## Minor Development Staff Report

**DATE:** NOVEMBER 6, 2024  
**TO:** DOUGLAS COUNTY BOARD OF COUNTY COMMISSIONERS  
**THROUGH:** DOUGLAS J. DEBORD, COUNTY MANAGER  
**FROM:** TERENCE T. QUINN, AICP, DIRECTOR OF COMMUNITY DEVELOPMENT   
**CC:** HEATHER SCOTT, AICP, PRINCIPAL PLANNER  
CURTIS J. WEITKUNAT, AICP, LONG RANGE PLANNING MANAGER  
STEVEN E. KOSTER, AICP, ASSISTANT DIRECTOR OF PLANNING SERVICES  
**SUBJECT:** RIVER CANYON FILING 2, 4<sup>TH</sup> AMENDMENT – MINOR DEVELOPMENT PLAT

**PROJECT FILE:** SB2024-019

DATE OF PREPARATION:	03/19/2024
SCALE:	1" = 30'
SHEET 3 OF 3

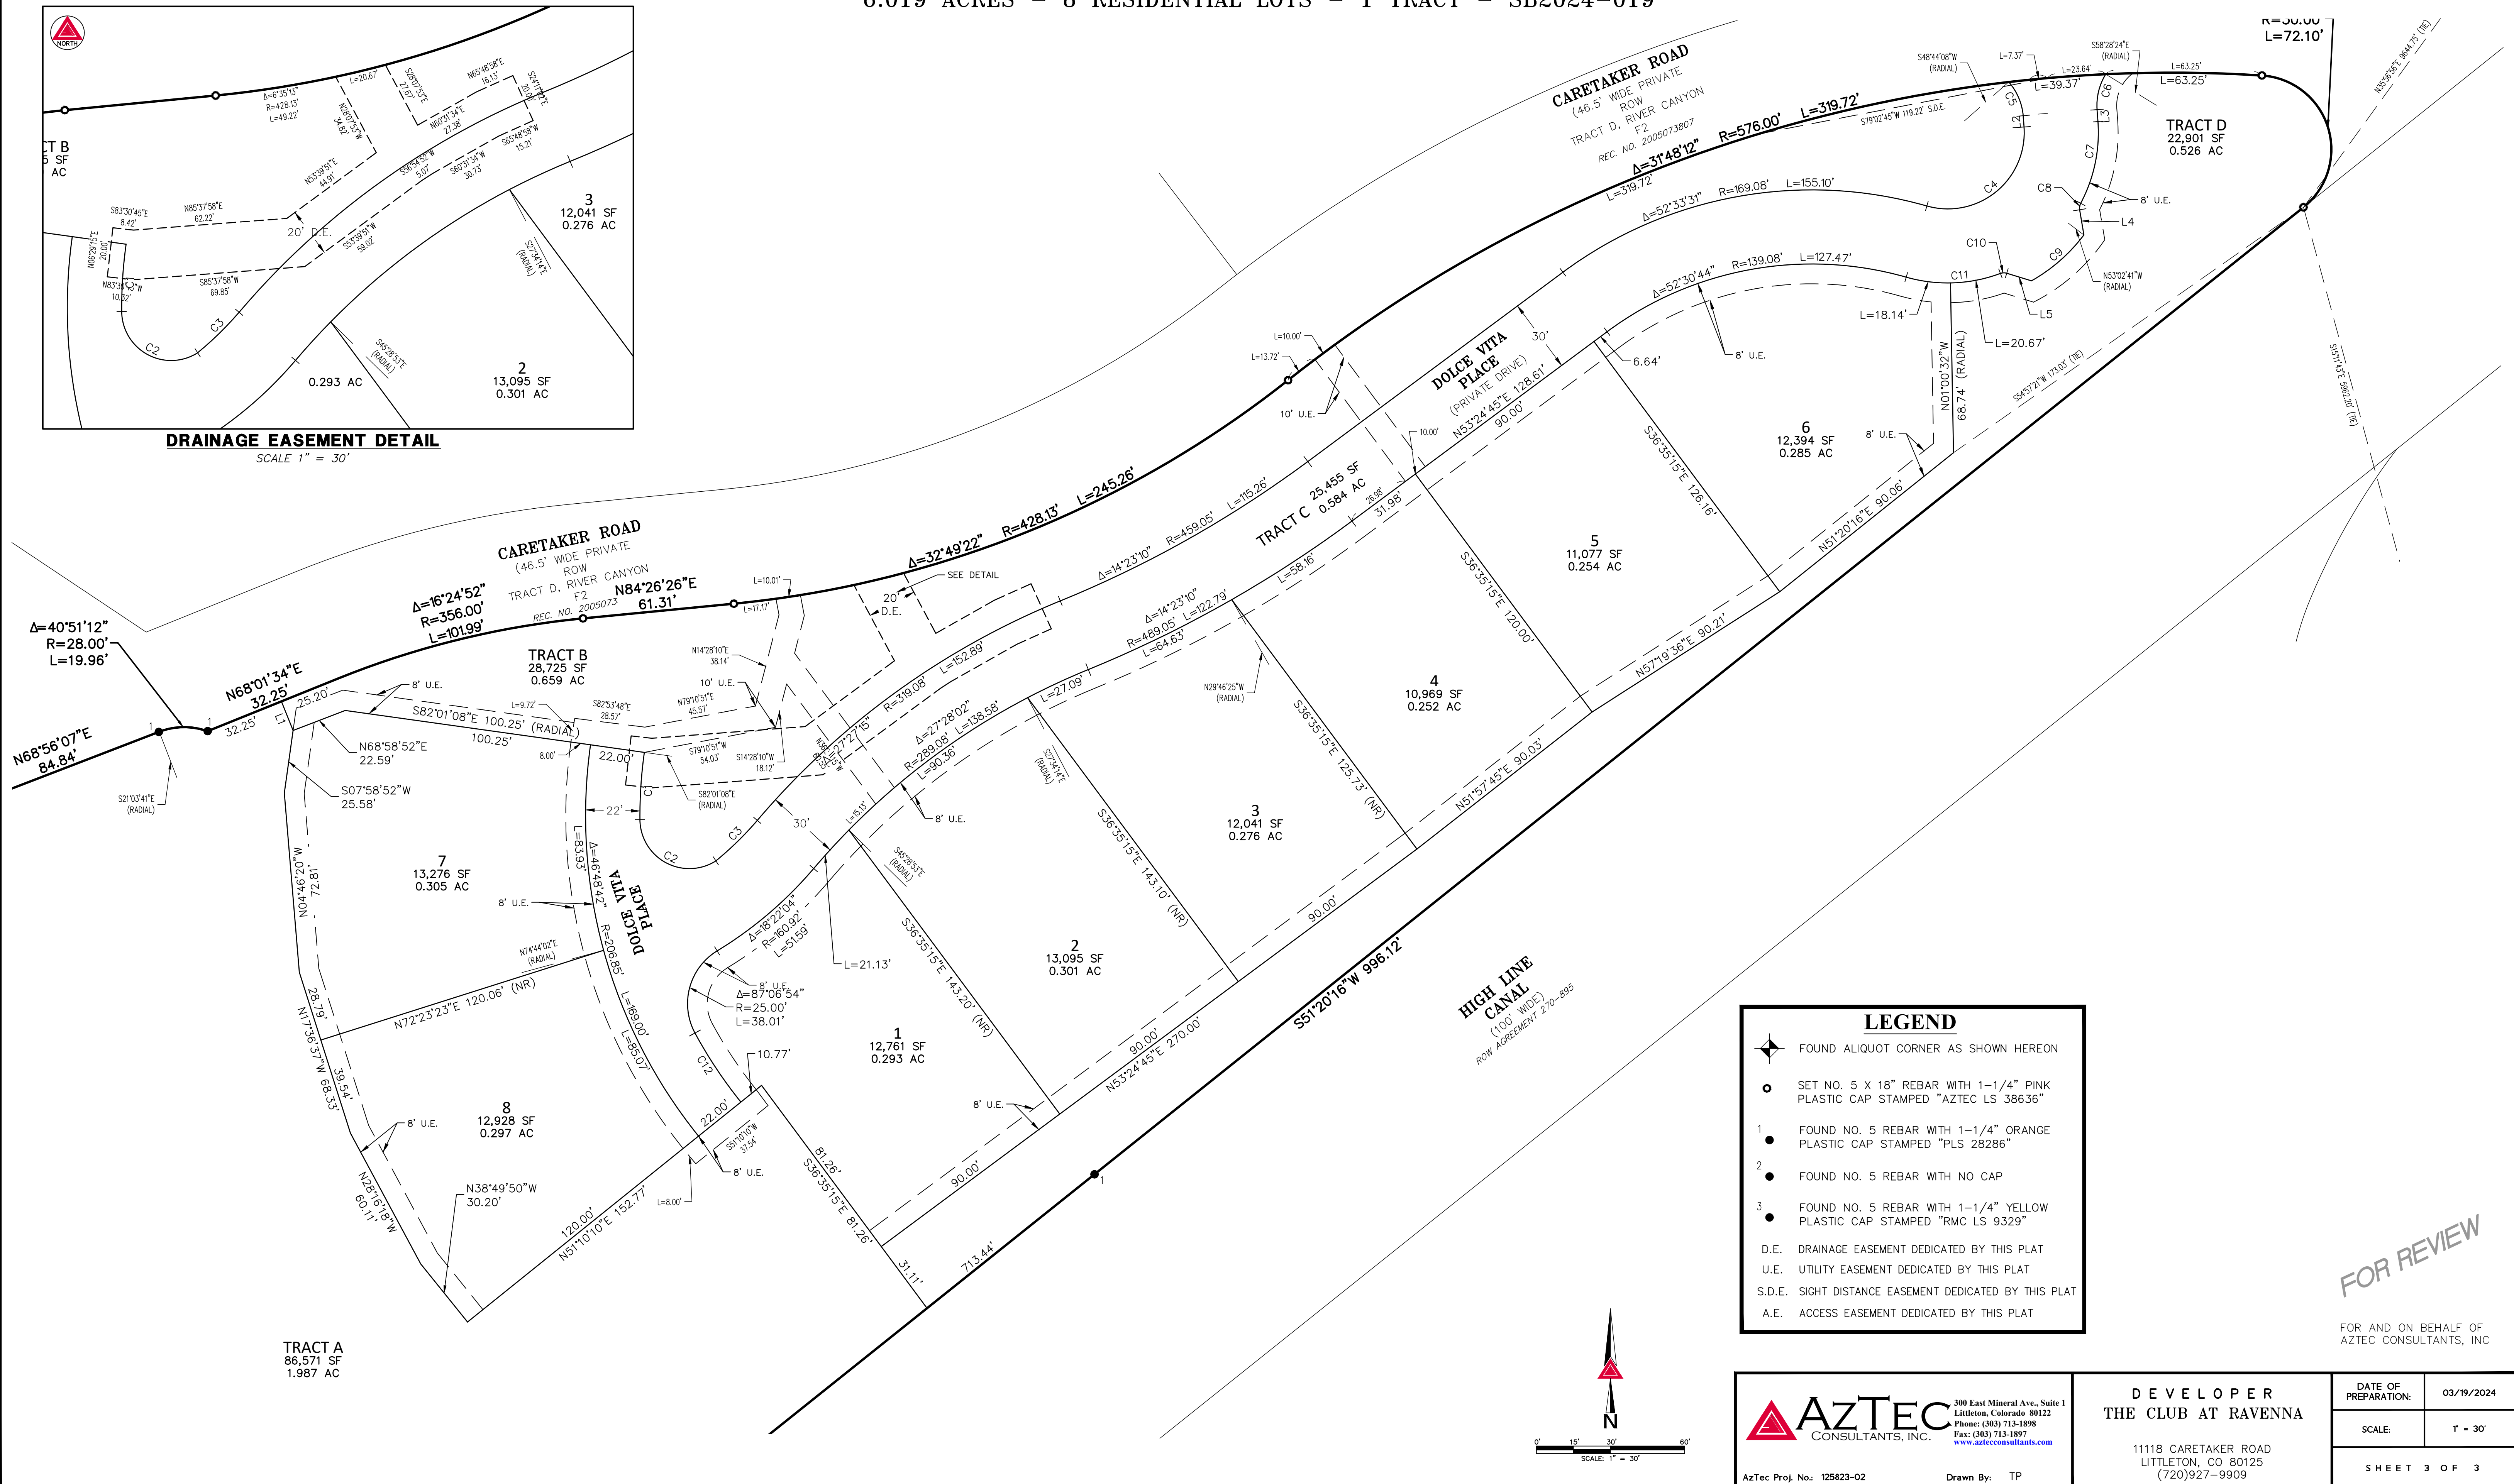
Response: Sight distance easement has been shown and dimensioned on sheet 3 of the plat. In the past with Douglas County we have only had to specify 24" instead of 36". We have added a note saying the following "no object within the sight distance easement shall be more than twenty-four (24) inches above the flowline of the adjacent street"
